DRB Application No.: 10DRB-70095 Project # 1008137  
Project Name: Westgate Heights Subd.  
Agent: DSA Architects LLC Phone No.: 342-6200

**FILE: Project 1008137  
10EPC-40004 Amended Site Development Plan for Building Permit**

**Re:** Project #1008137, 10EPC-40004, Site Development Plan for Building Permit Amendment

Project Number	
Drawn By	
Checked By	
Issue Date	JANUARY 21, 2012
BUILDING ELEVATION	
Scale	AS SHOWN
A-201	
SHEET 1 OF 3

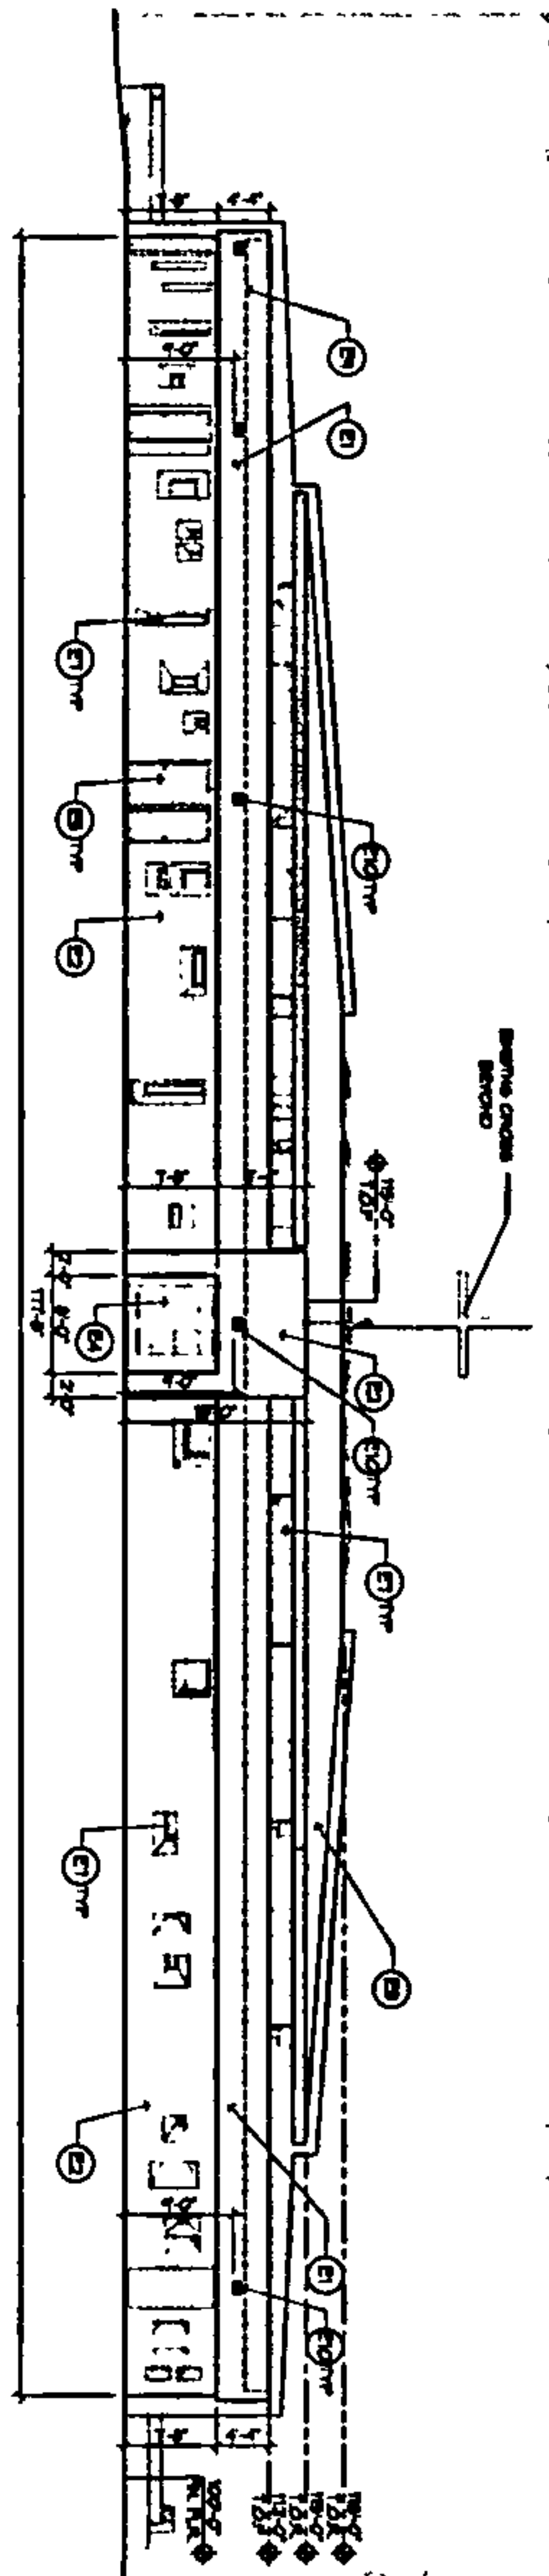
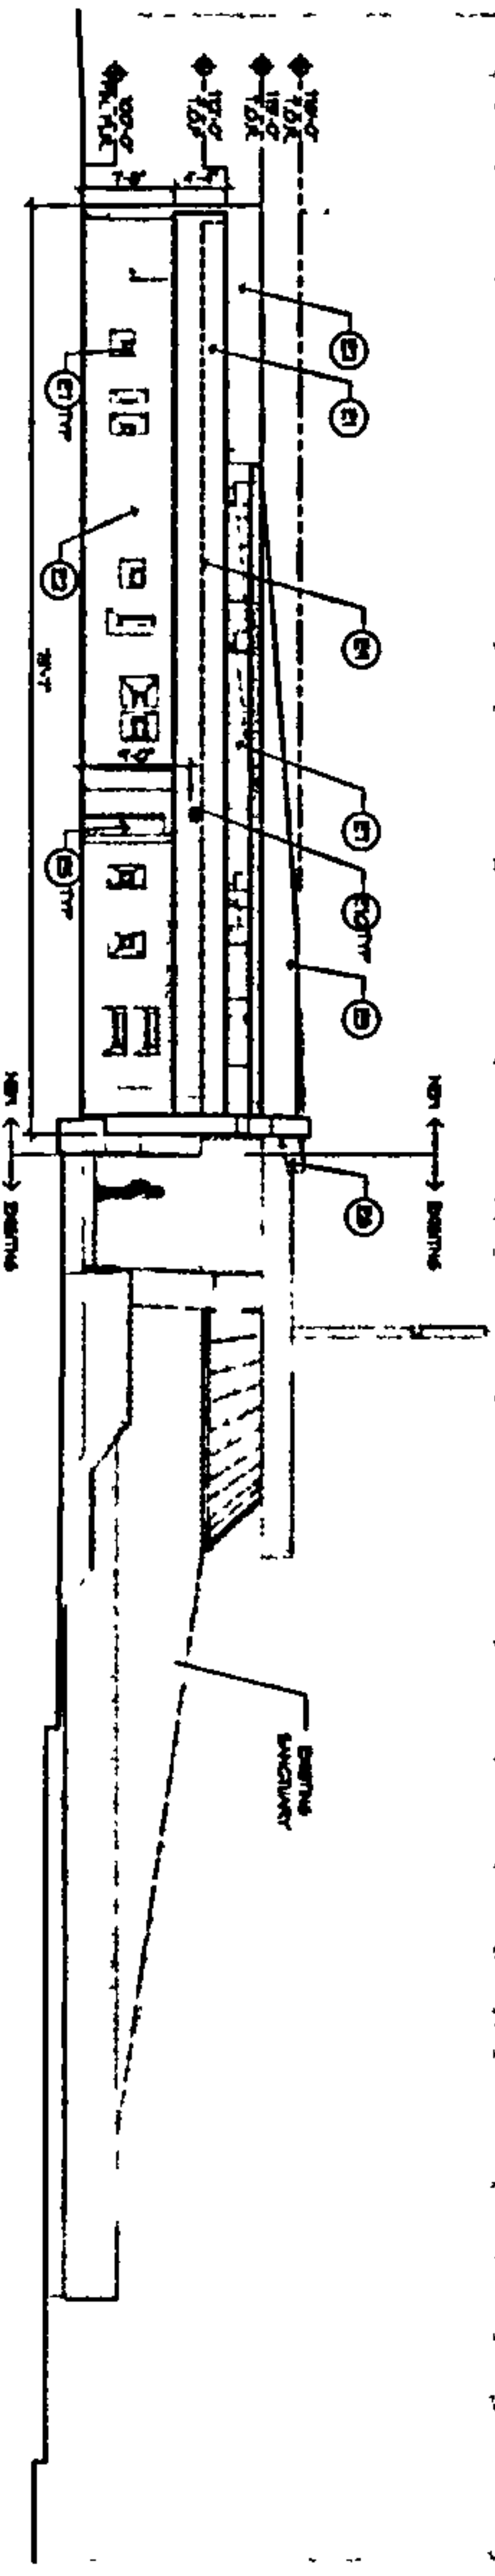
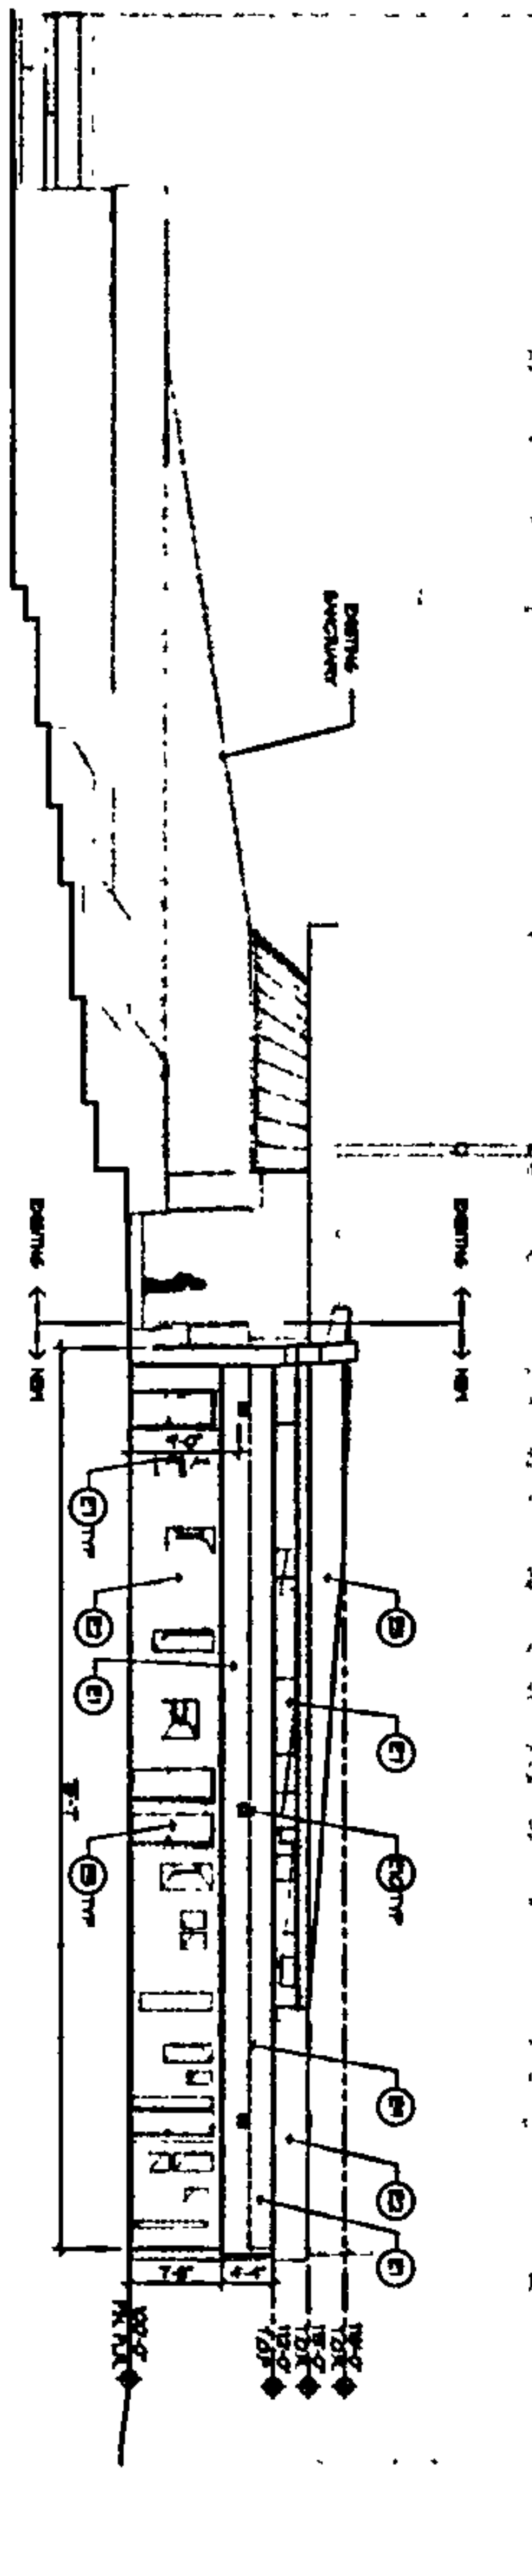
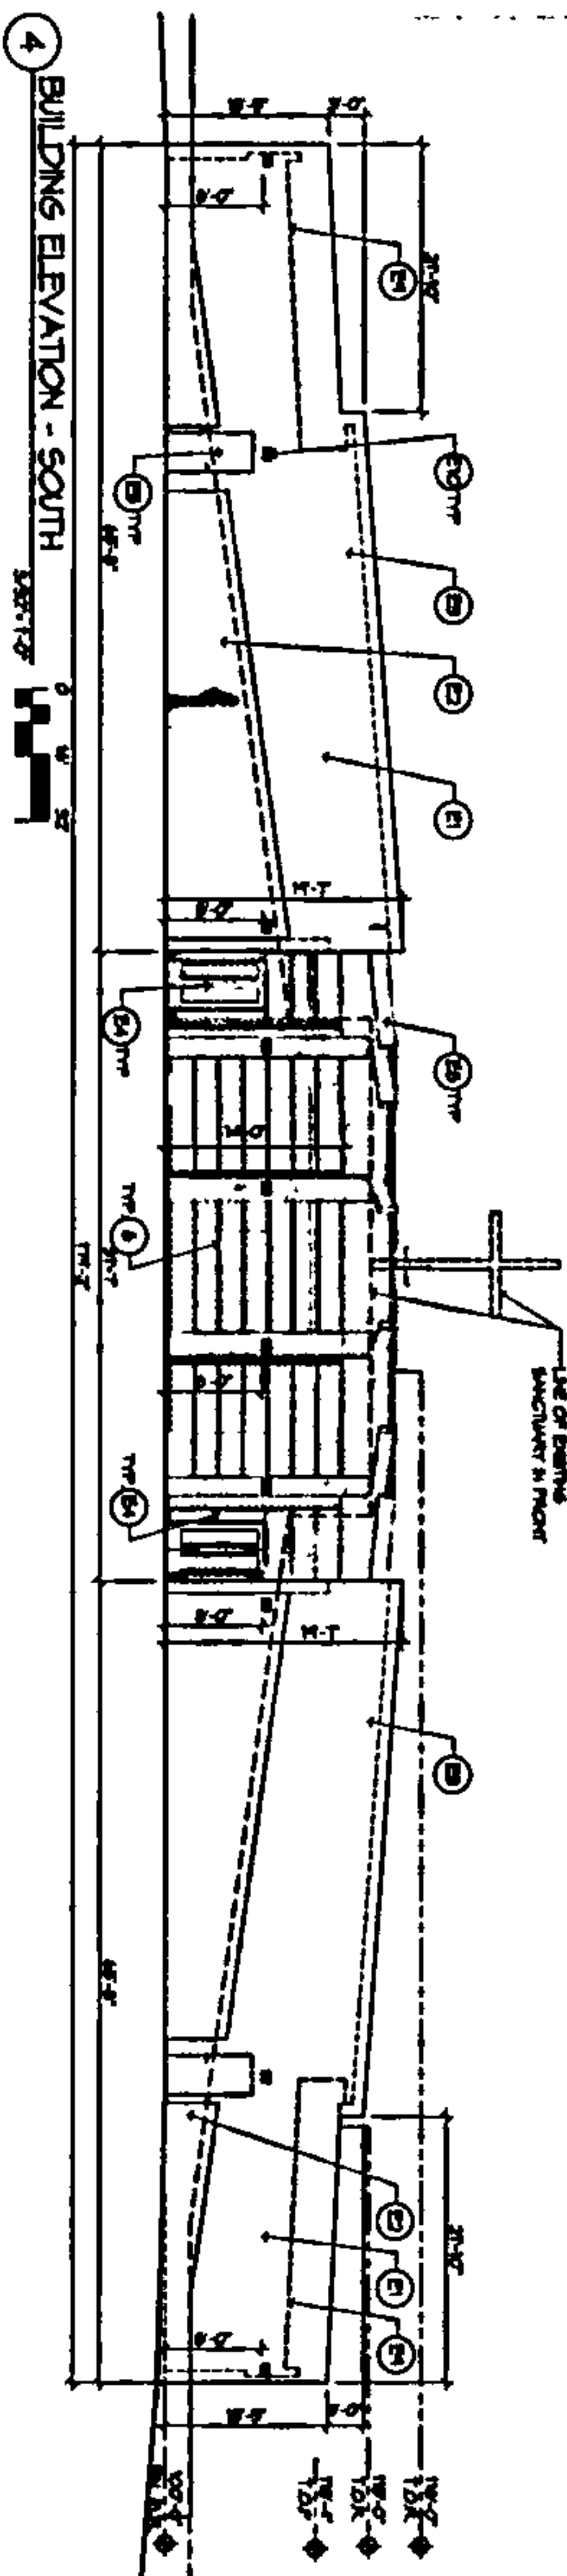
- d. Bollard and/or building-mounted lighting shall be added along facades of the fellowship hall and future office building to improve safety and security.

13. Architecture: On the elevations sheet, the metallic roof shall be noted as "low-reflective" to prevent unnecessary glare to surrounding properties. Standing seam metal roofing with the metallic color silver is acceptable under this condition.

- d. Building mounted lighted has been added to sheet A-201.
9. Landscaping
- a. Existing landscaping on the north part of the site has been hatched.
  - b. Parking area tree calculations have been corrected.
